Reference: Hanford Waste Vitrification Plant
DOE Contract DE-AC06-86RL10838
Fluor Contract 8457

**FLUOR DANIEL**US DEPARTMENT OF ENERGY
HANFORD WASTE VITRIFICATION PLANT**DESIGN CHANGE NOTICE**

Specifications for
flow meter and pressure
transmitter to be added ^{per} CR1056

DCN - 0119

Section 2 Insert (for A160-17801)

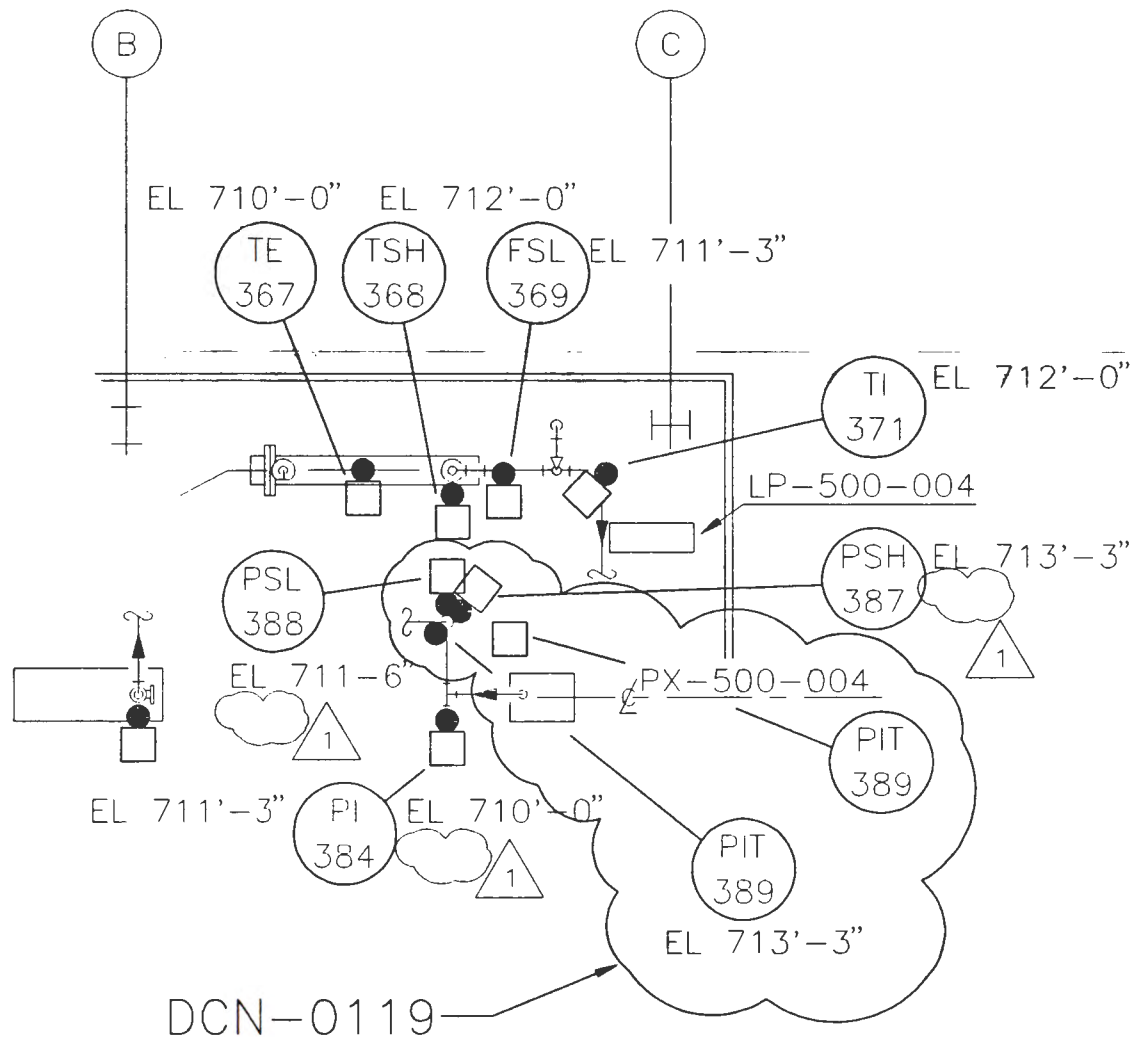
PRESSURE INDICATING TRANSMITTER

The following pressure indicating transmitter shall be assembled, furnished and installed:

Tag No: PIT-FWX-389
 Range: 0-220 psig
 Operating Press: 100 psig
 Mounting: 2" yoke

Transmitter shall be two wire electronic type with 4-20 mA DC output signal

FLOW TOTALIZING METER

The following flow totalizing meter shall be assembled, furnished and installed:

Tag No: FAI-SWX-013
 Range: 100-1500 gpm
 Normal Flow: 700 gpm
 Mounting: 150 lb R.F. Flange

A suggested meter is the BROOKS propeller meter Model 3352

BASE DOC. NO. H-2-121203

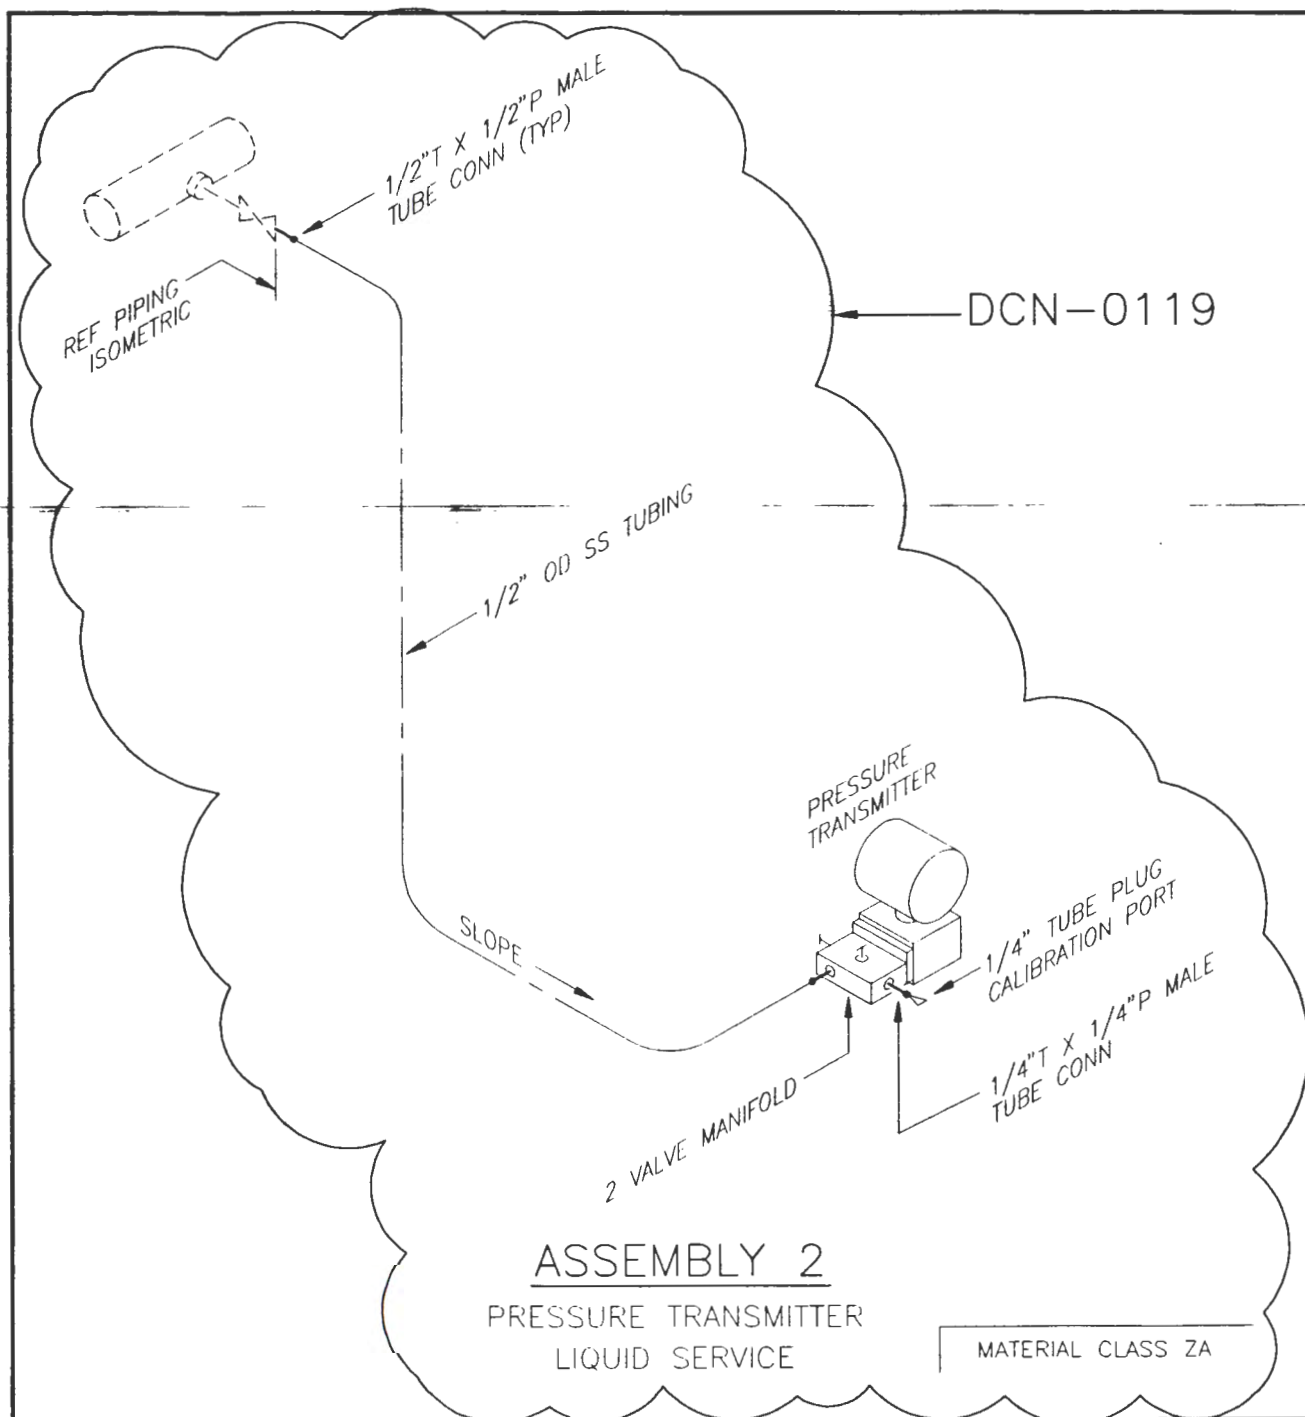
SPECIFICATIONS FOR FLOW
METER AND PRESSURE TRANSMITTER
TO BE ADDED PER CR1056
